**Economic and Social Council**Distr.: General
18 November 2021

World Forum for Harmonization of Vehicle Regulations**Working Party on Noise and Tyres****Seventy-fifth session**

UN Regulation No. 51 (Noise of M and N categories of vehicles)**Proposal for Supplement 10 to the 03 series of amendments
to UN Regulation No. 51****Submitted by the Informal Working Group on Additional Sound
Emission Provisions***

Flowchart for vehicles tested according to paragraph 3.1.2.1. of Annex 3 to this Regulation - Gear selection using locked gear PART 1

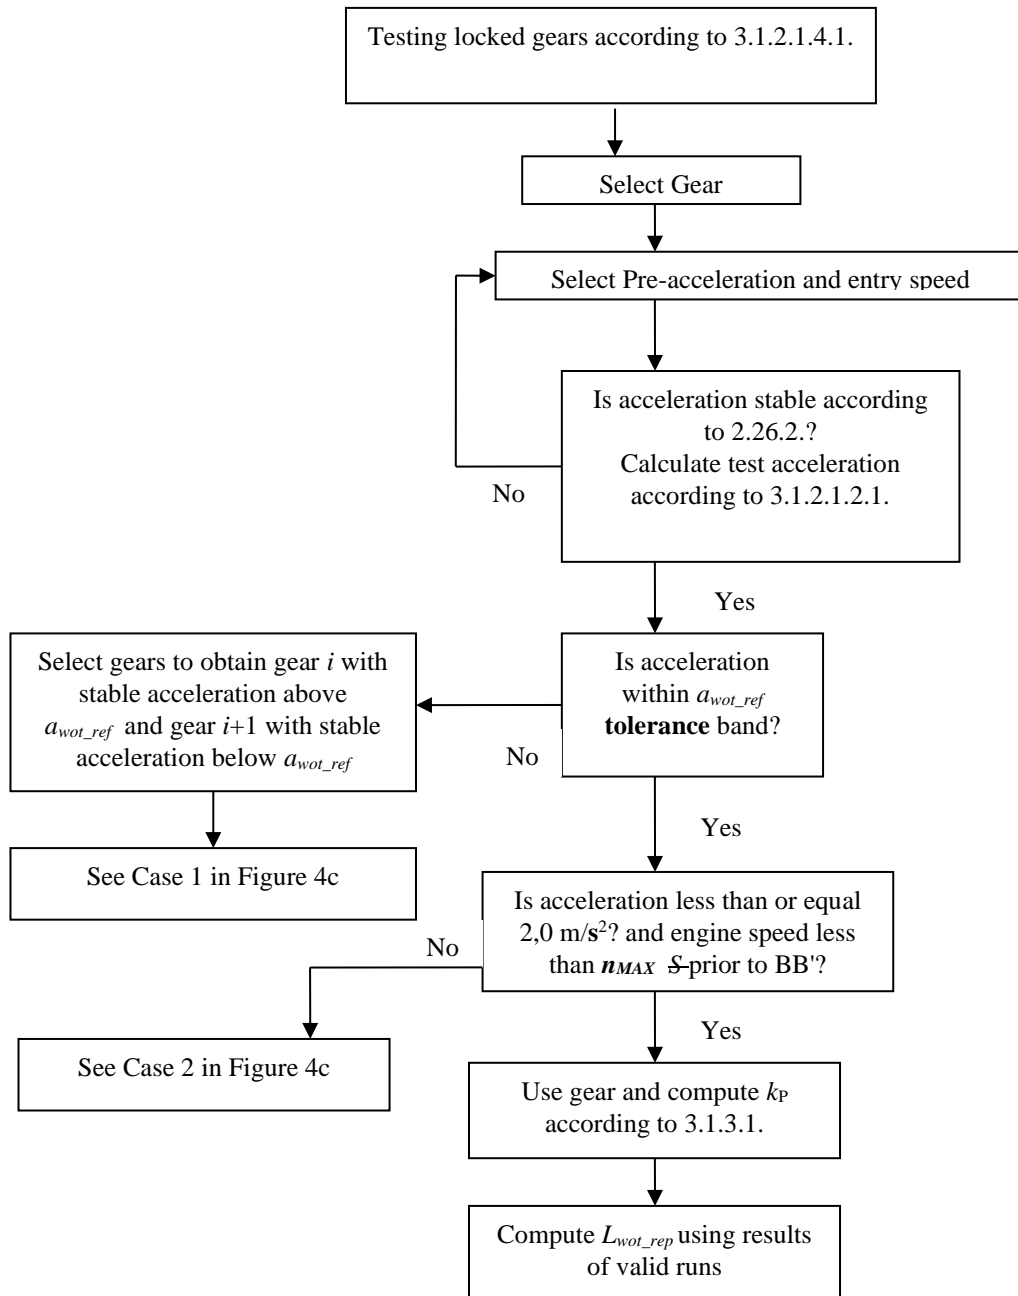
Annex 3 - Appendix, Figure 4b, amend to read:

12. Annex 3, figures 4b to 4f have been updated according to the introduction of n_{MAX} mentioned above.

"Figure 4c
**Flowchart for vehicles tested according to paragraph 3.1.2.1. of Annex 3 to this Regulation –
 Gear selection using locked gear PART 2**

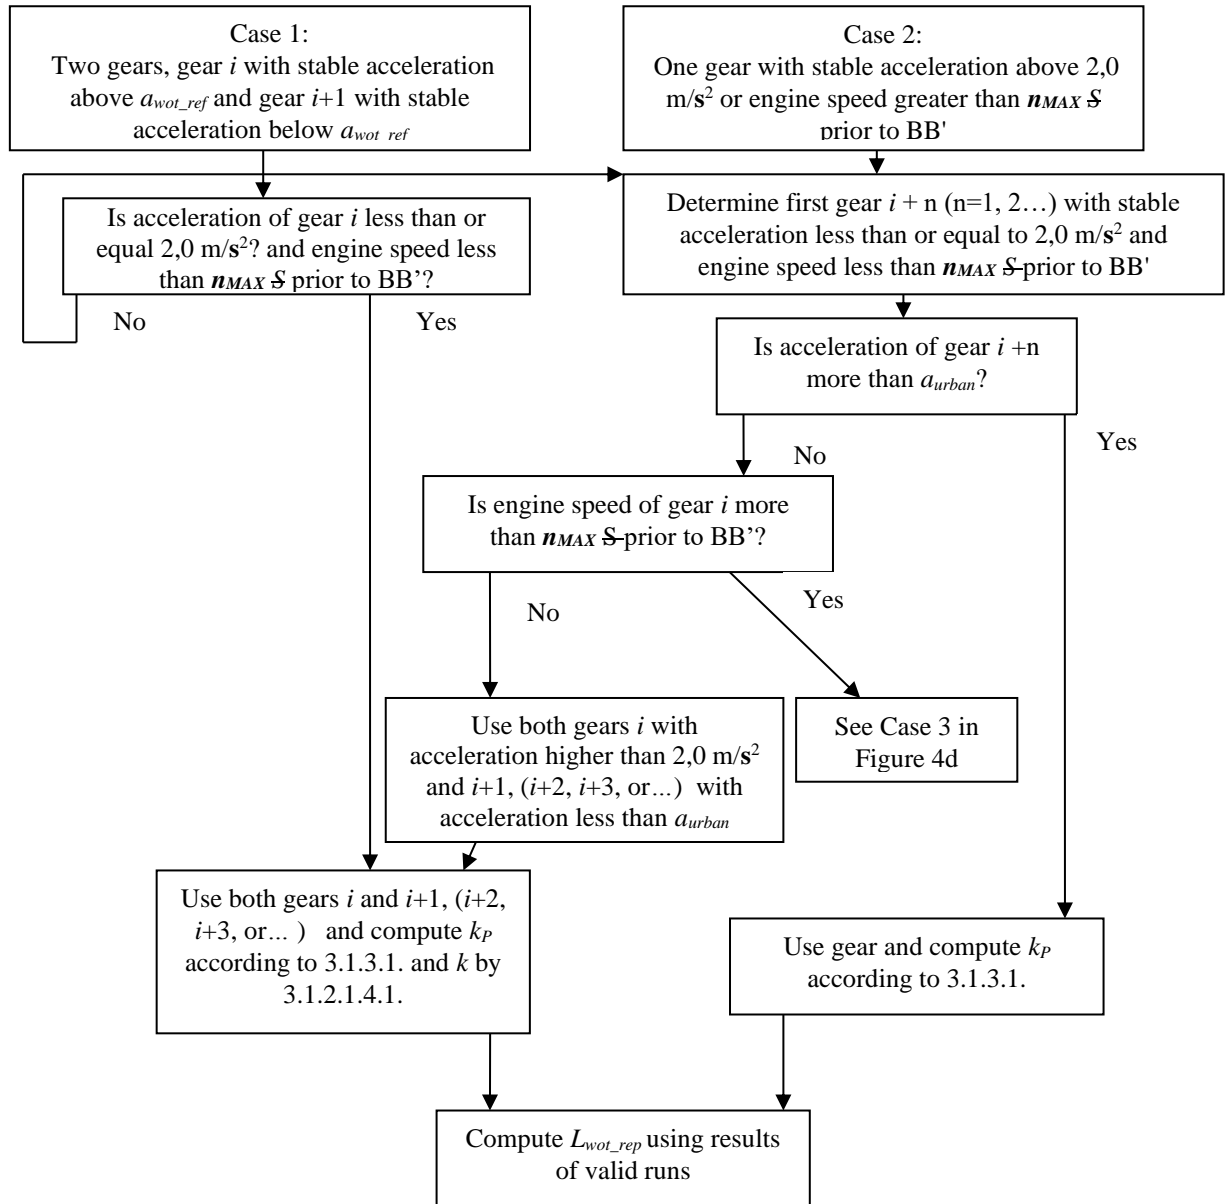
Annex 3 - Appendix, Figure 4c, amend to read:

Flowchart for vehicles tested according to paragraph 3.1.2.1. of Annex 3 to this Regulation – Gear selection using locked gear PART 3

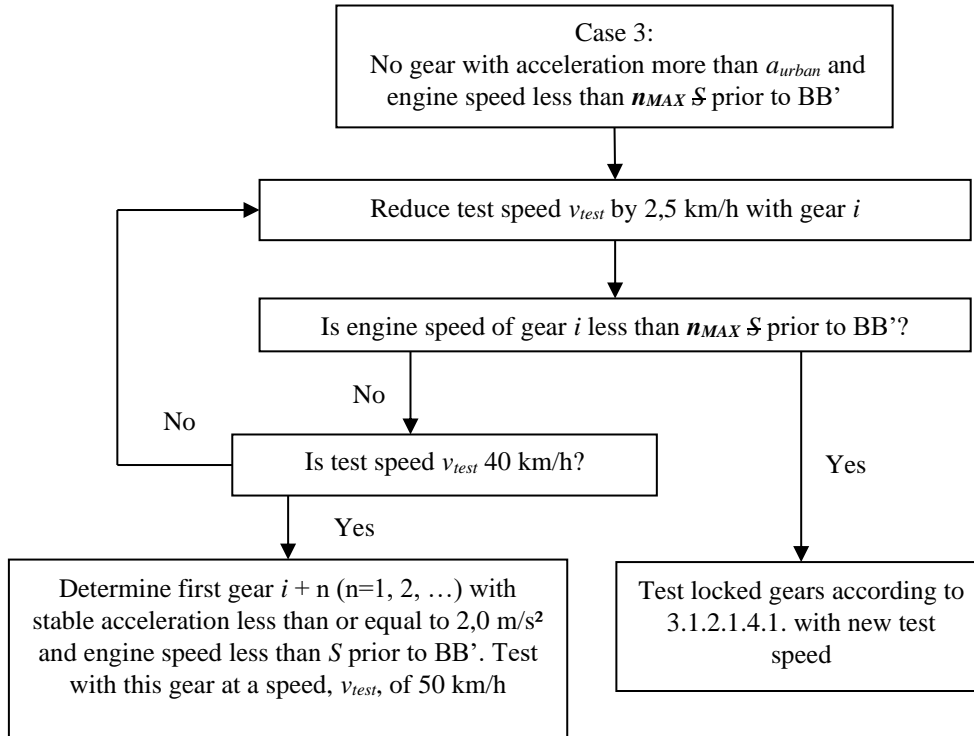
Annex 3 - Appendix, Figure 4d, amend to read:

"Figure 4e
**Flowchart for vehicles tested according to paragraph 3.1.2.1. of Annex 3 to this Regulation –
 Gear Selection using non-locked gears**

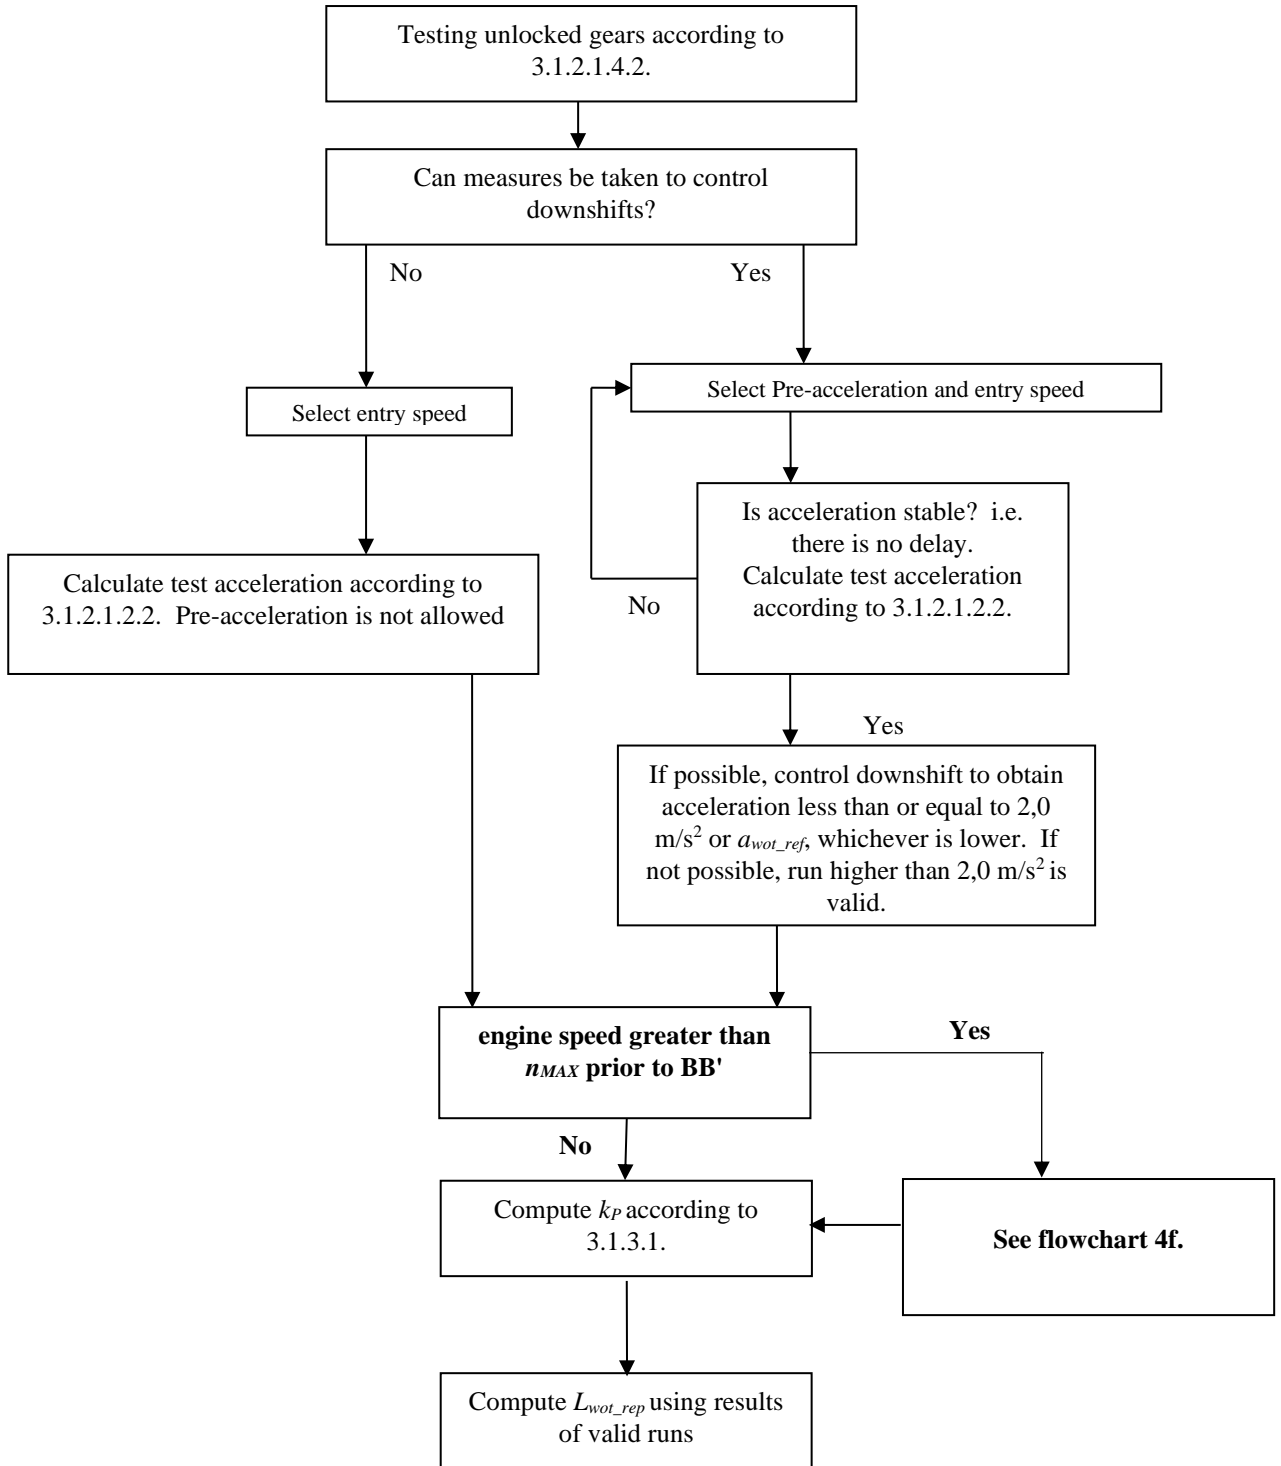
Annex 3 - Appendix, Figure 4e, amend to read:

Flowchart for vehicles tested according to paragraph 3.1.2.1.4.2. of Annex 3 to this Regulation – Gear Selection using non-locked gears

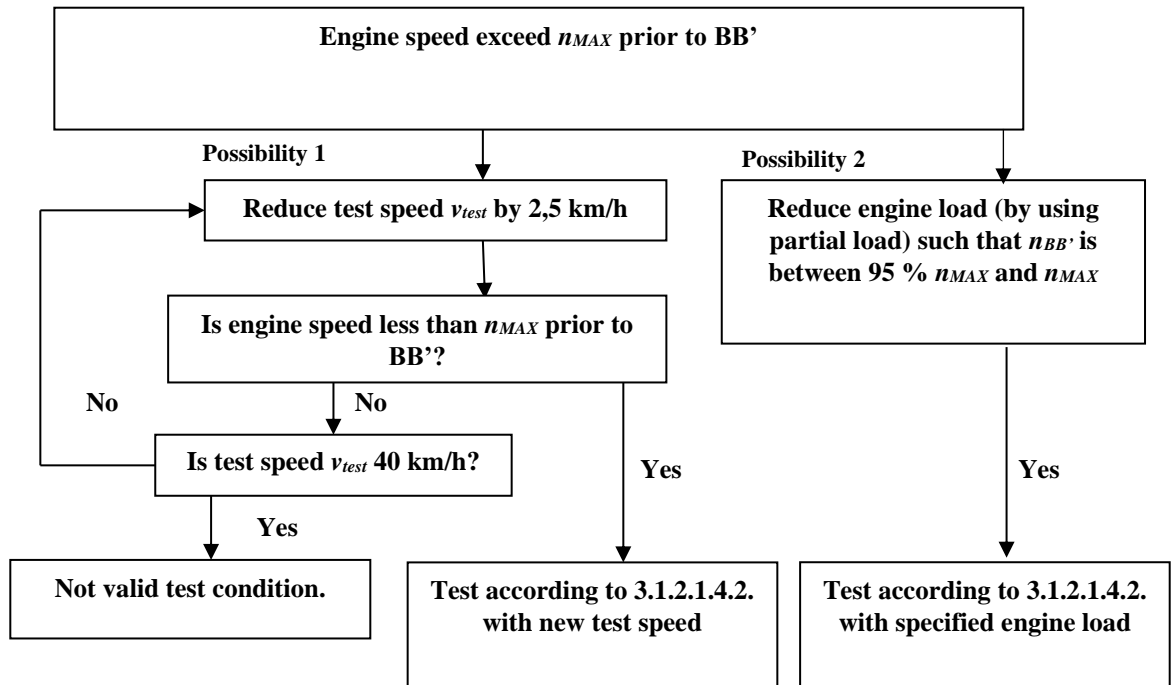
Annex 3 - Appendix, add a new Figure 4f, to read:

- (a) **accelerations beyond 2.0 m/s². Any measure used by manufacturer for the above-mentioned purposes shall be documented in the test report.** The achieved acceleration a_{wot_test} shall be greater or equal to a_{urban} .
- (b) **a test engine speed exceeding n_{MAX} (see Appendix 1, figure 4f).**
- (i) **Therefore, the vehicle test speed v_{test} may be reduced in steps by 2.5 km/h. In no case the vehicle test speed shall be reduced to a vehicle speed below 40 km/h, or**
- (ii) **The engine load is reduced to avoid a downshift to a gear ratio where n_{MAX} is exceeded.**
